■ ENGINE MOUNT

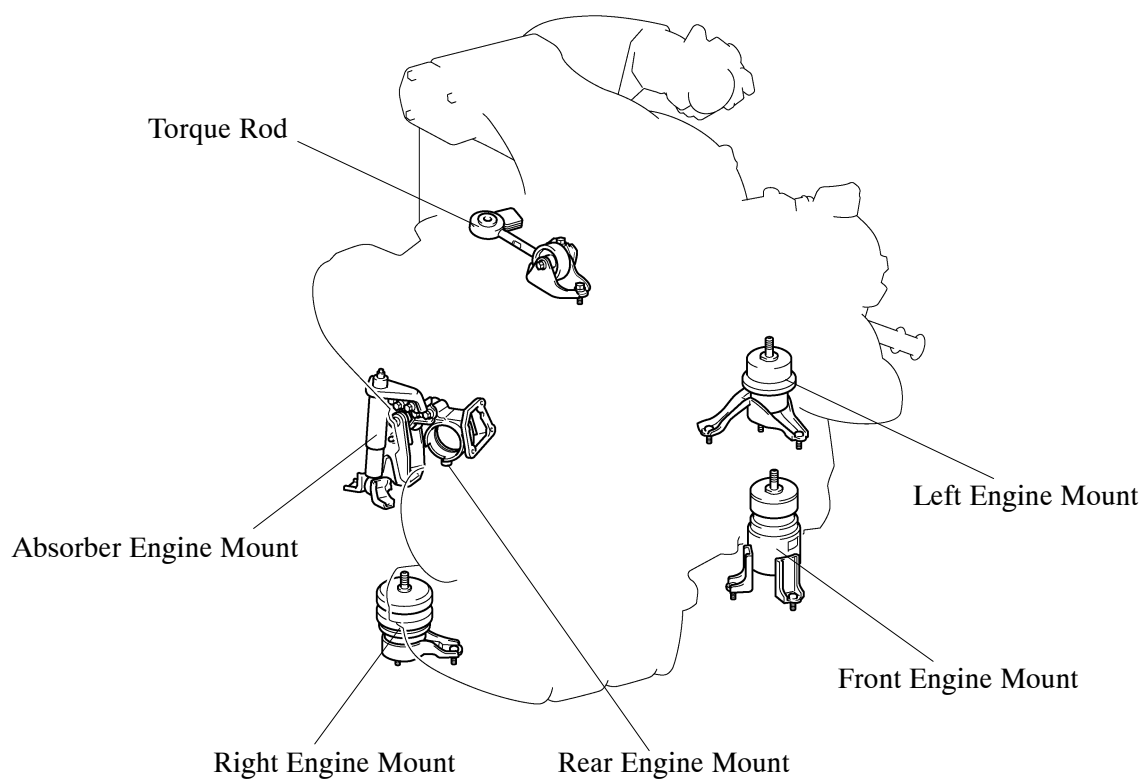
— Main Changes from Current RX330 —

- The front and rear engine mounts have been relocated.
- An absorber engine mount is used for the rear.
- The engine absorber mount is used on the rear engine mount and a hydraulic engine mounts are used on the right and left sides to realize low noise and vibration and to achieve high levels of both riding comfort and drivability.
